UNITED STATES PATENT AND TRADEMARK OFFICE

APPLICATION NO.	FILING DATE	FIRST NAMED INVENTOR	ATTORNEY DOCKET NO.	CONFIRMATION NO.
09/488,373	01/20/2000	Toru Morita		4355

Office Action Summary

**FIG.1**

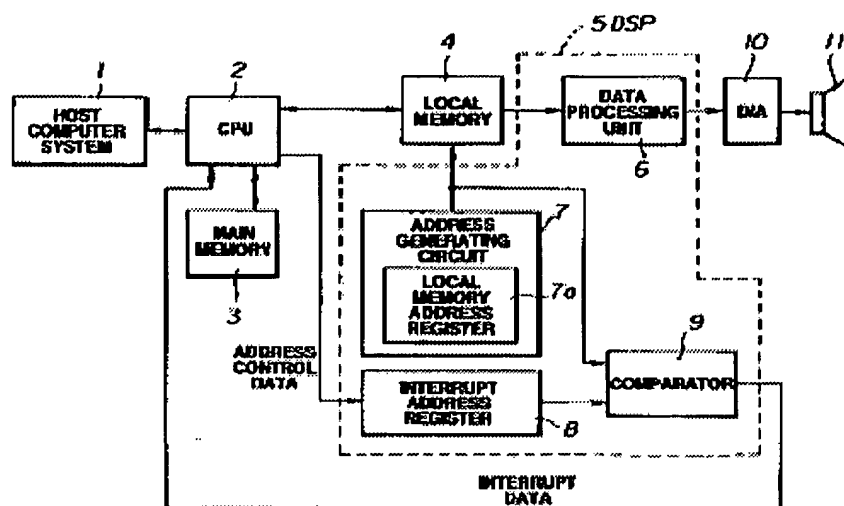
Regarding claim 1, Furuhashi discloses a method for generating playback sound in an electronic device through an interrupt information generating apparatus and speech information processing apparatus including :CPU (2) and a speaker (11) (See Figure 1 below) ;

FIG. 3

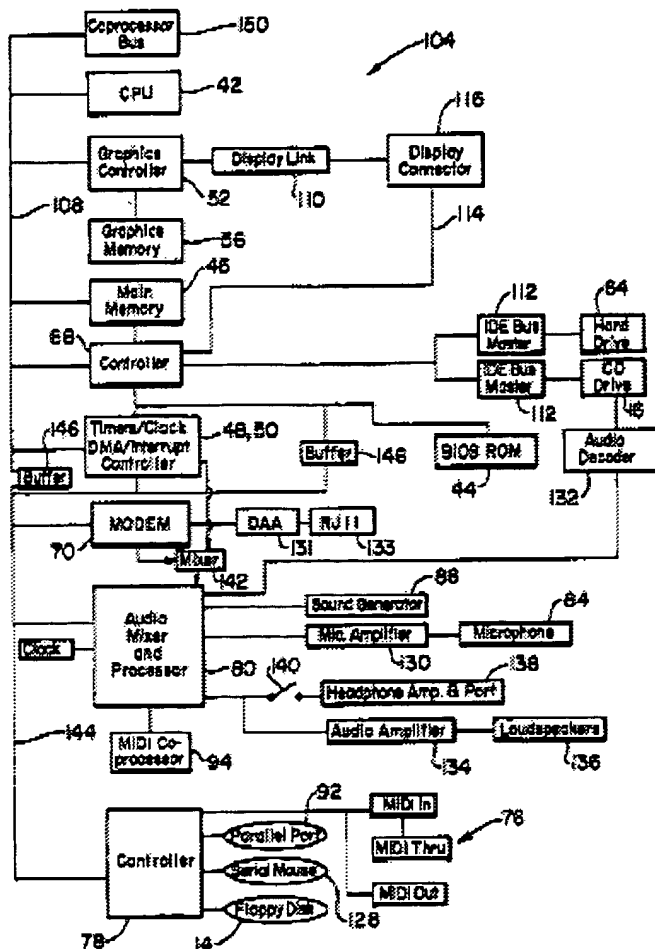
9. Claim 5 is rejected under 35 U.S.C. 103(a) as being unpatentable over Arnold et al., (U. S. Patent 5,908,997), in view of Furuhashi et al. (5,787,397). Regarding Claim 5, Arnold discloses a method for clearly generating a clear playback sound, in an electronic device through a music information management system (12 of Figure 1), comprising: a CPU (42), timer (50) and a speaker (136), which read on "CPU", "timer" and "speaker"; a MIDI Audio subsystem that provides the components for sound generation; reading image and

subsystem which includes a graphics decoder for generating video images under command from the CPU subsystem and through the Multimedia Audio subsystem includes an audio mixer and processor under control by the CPU (42), column 9, line 43 [This reads on reading image and audio data under CPU control]; and a timer connected to the CPU. Although Arnold teaches on the above-mentioned elements he does not teach dynamically altering the CPU interrupt signal in accordance with read audio data. However, the concept dynamically altering the CPU interrupt signal in accordance with read audio data was well known in the art at the time of filing as taught
